# UNITED STATES DEPARTMENT OF THE INTERIOR BUREAU OF LAND MANAGEMENT

### Schematic - Vertical Production Well Name: POKER LAKE UNIT #213 Field: Nash Draw (Del. BS: AV)

## Poker Lake Unit 213 30-015-33859 BOPCO L.P. Conditions of Approval

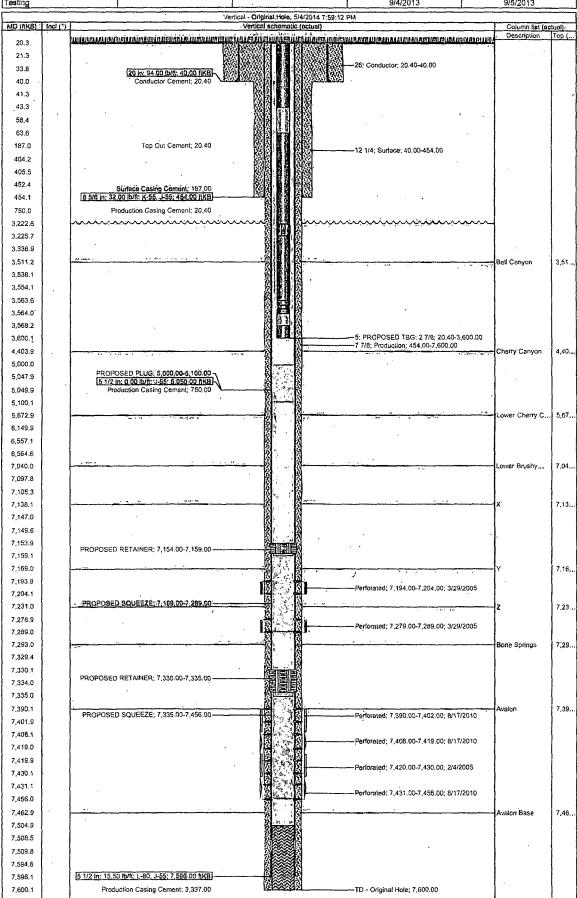
- 1. DV tool plug shall be a minimum of 150 feet in length set from 5100-4950'. WOC and Tag.
- 2. Must conduct a casing integrity test before perforating and fracturing. Submit results to BLM. Notify BLM if test fails.
